Subject: Brunswick Steam Electric Plant, Unit Nos. 1 and 2
Renewed Facility Operating License Nos. DPR-71 and DPR-62
Docket Nos. 50-325 and 50-324
Response to Request for Additional Information Regarding Request for
Emergency License Amendment - Technical Specification 3.8.1, *AC Sources –
Operating, One-Time Extension of Emergency Diesel Generator Completion
Times and Suspension of Surveillance Requirements*

Response to Request for Additional Information

On November 24, 2017, by electronic mail, the NRC provided a request for additional information (RAI) regarding the LAR. Those questions, and Duke Energy's responses, are provided below.

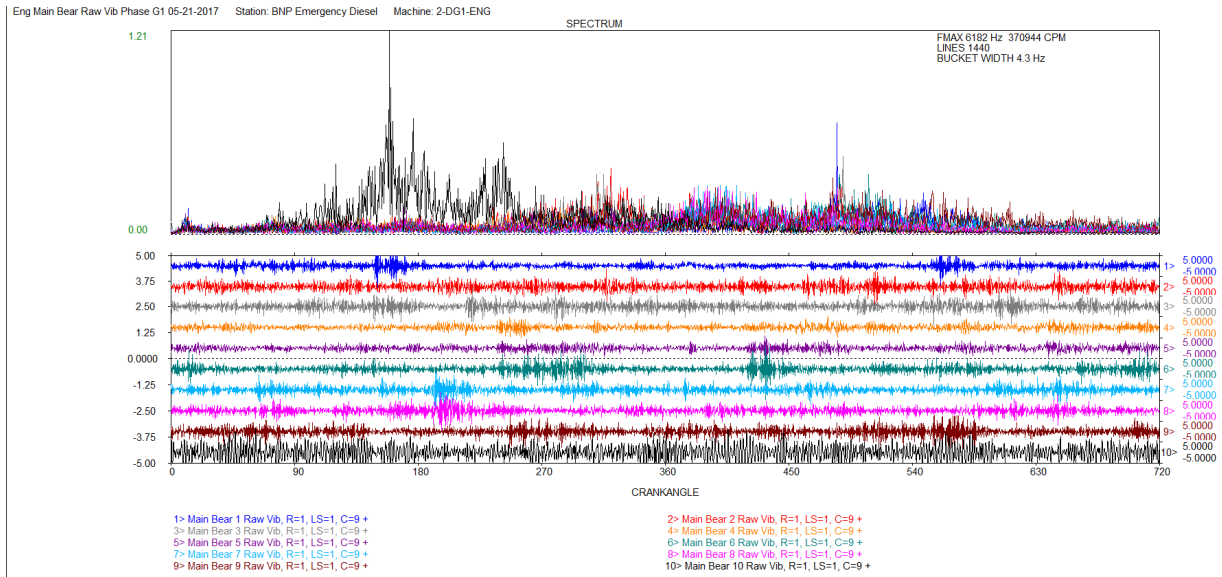
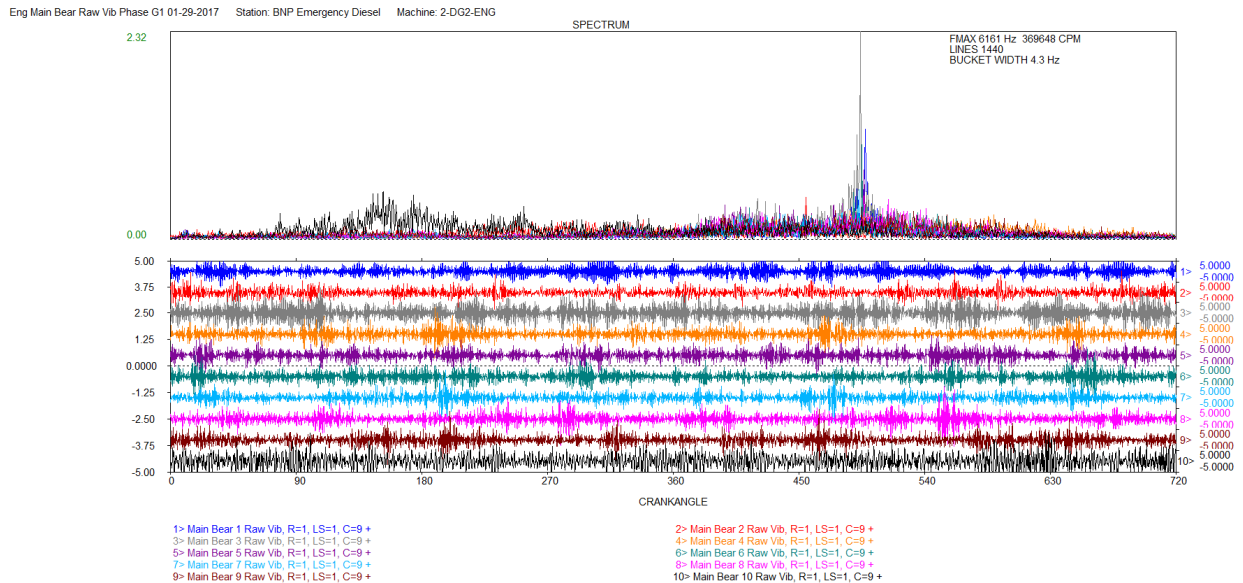
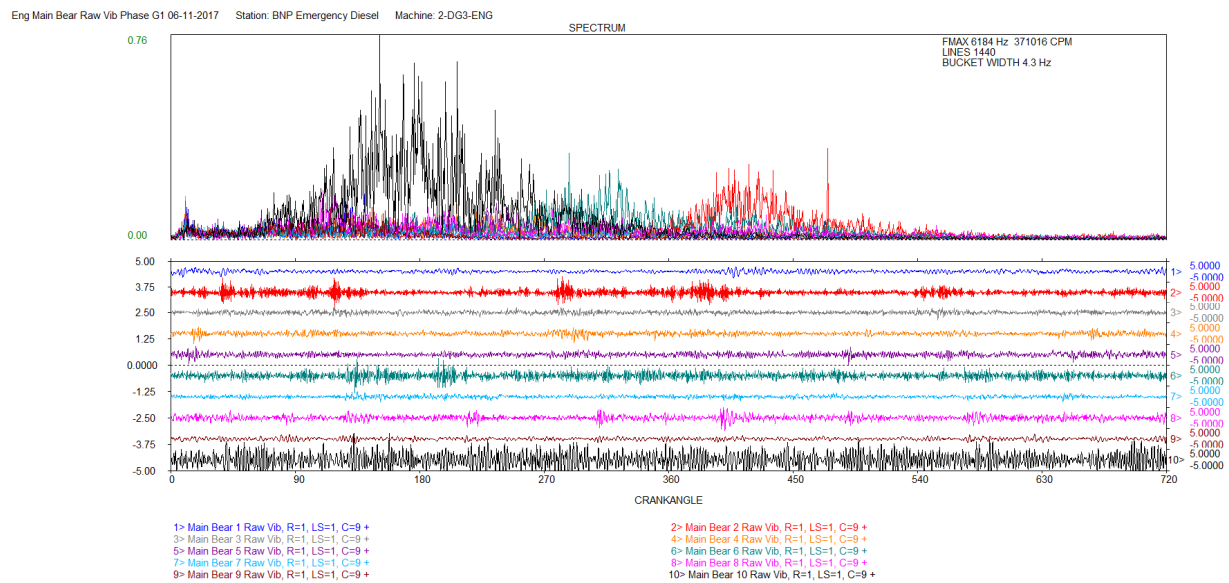
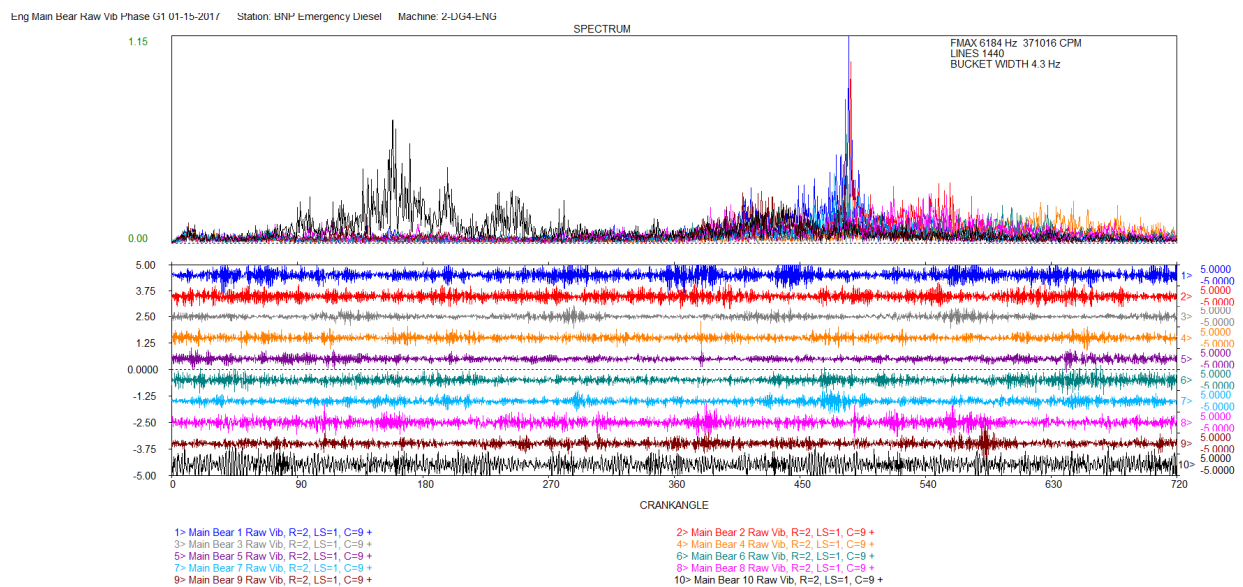
Discuss the vibration data for EDG 4 for the past four years, and compare it to the vibration data for EDGs 1, 2 and 3 for the past four years.

Latest collected vibration data (i.e., early 2017) for EDGs 1, 2, 3, and 4 are similar in magnitude. The latest data has been collected with a Windrock 6320/PA. The older data was collected with a RECIP-TRAP RT9260. Each used different sets of software, thus the different representations of data is due to the software capabilities.

Each data point captures vibrations for each of 10 bearings on the EDGs. The data shows overall stable vibration data collections, and no bearing defects have been identified.

Latest maximum Fast Fourier Transform (FFT) magnitudes with individual bearing readings were collected for each EDG as follows:

The vibration data shown in the response to MEB Question 7 is from the Windrock MD software. For each EDG, the raw vibration signals for each of the 10 main bearings are shown in the bottom portion of the plot. Each plot represents one mechanical cycle (i.e., 720 degrees of crankshaft revolution) of the engine, so the x-axis shows 0 to 720 degrees. The y-axis scale on the lower portion of the plots are the same for all four EDGs (i.e., -5 to +5 g's). The top portion of the plot shows the 10 overlaid Fast Fourier Transforms (FFTs) of the raw vibration signatures. The x-axis of the upper portion is frequency from 0 to approximately 6180 Hz. The y-axis is

in g's, but the maximum y value shown is different for each of the four EDGs because it autoscales.

For example, the EDG 3 upper portion is scaled to a maximum of 0.76g, which is a smaller scale than the other three plots. The dominant vibration on EDG 3 is the main bearing 10, which is the generator inboard bearing (i.e., not one of the nine diesel engine bearings). All vibrations are in the normal range.
